SUBJECT: TECHNICAL SPECIFICATION AMENDMENTS PERTAINING TO
HEALTH PHYSICS ORGANIZATION CHANGES

The Commission has issued the enclosed Amendments Nos. 94 and 96 to Facility Operating Licenses Nos. DPR-44 and DPR-56 for the Peach Bottom Atomic Power Station, Units Nos. 2 and 3. These amendments consist of changes to the Technical Specifications (TSs) concerning the Health Physics organization in response to your application of June 3, 1980, as supplemented by letters dated May 19, 1981, July 7, 1982, and January 28, 1983.

PEACH BOTTOM ATOMIC POWER STATION, UNIT NO. 2

PEACH BOTTOM ATOMIC POWER STATION, UNIT NO. 3

Figure 6.2-2

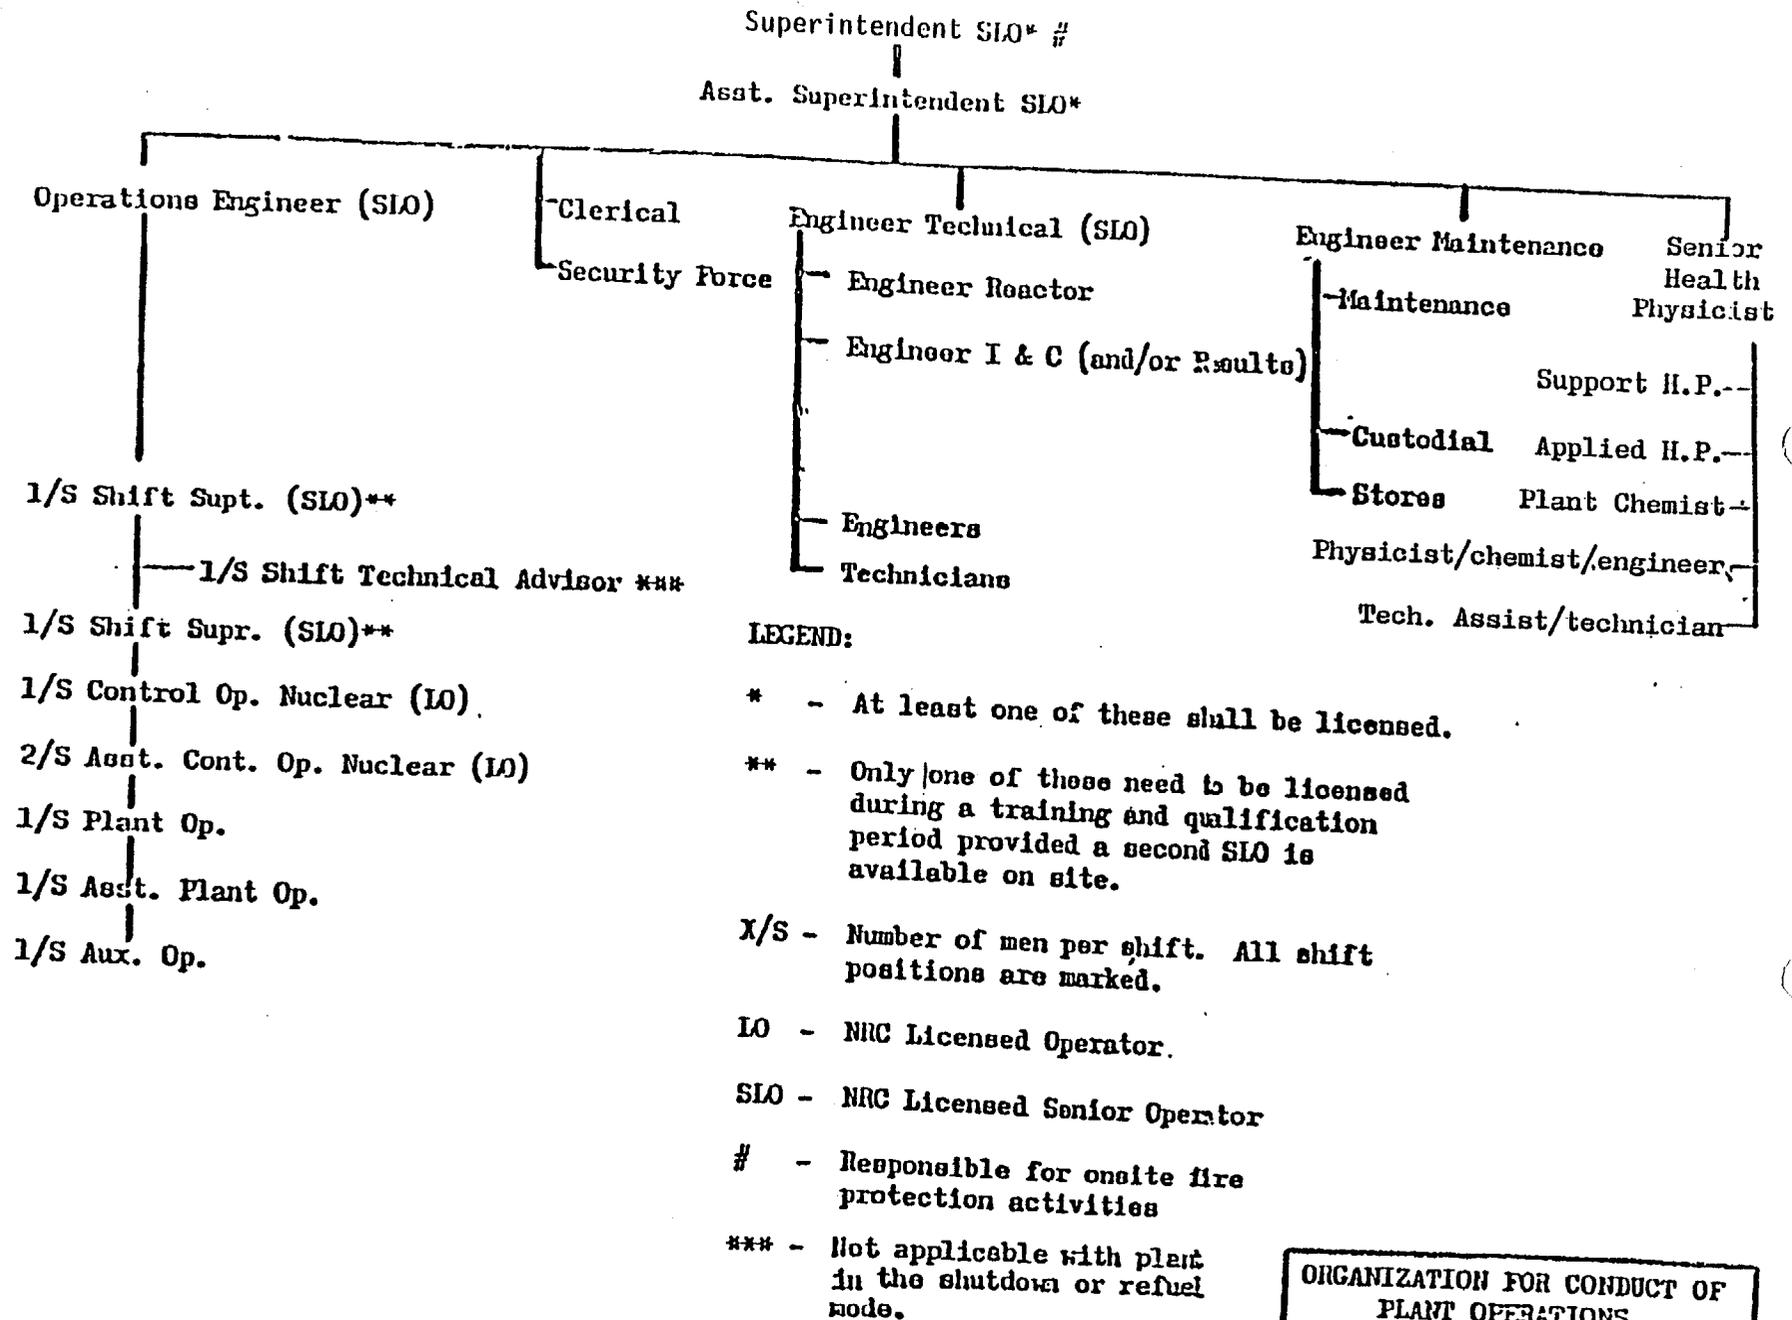
The Philadelphia Electric Company (the licensee) made application by letter dated June 3, 1980, as supplemented by letters dated May 19, 1981, July 7, 1982, and January 28, 1983, to permit changes to Section 6 (Figure 6.2-2) of the Appendix A Technical Specifications (TSs) to reflect changes in the Health Physics organization structure.

The licensee has restructured the Peach Bottom Atomic Power Station Health Physics' organization, Figure 6.2-2, to appoint a new staff position, Senior Health Physicist, who reports directly to the Assistant Superintendent. The Senior Health Physicist will assume the duties and responsibilities of the Radiation Protection Manager (presently described as the Engineer-Health Physics in the Peach Bottom TSs) and will directly supervise the Peach Bottom Station's health physics and chemistry functions. Currently, the Station's Engineer-Health Physics or Radiation Protection Manager reports to the Assistant Superintendent. Thus, the licensee's proposed change will give the Senior Health Physicist a direct channel of communication with upper level Station management and will provide some additional separation from operational pressures. This change meets the recommendations of NUREG-0731, "Criteria for Utility Management and Technical Competence", and Regulatory Guide 8.8, Section C.1.b(3) and, therefore, is acceptable.
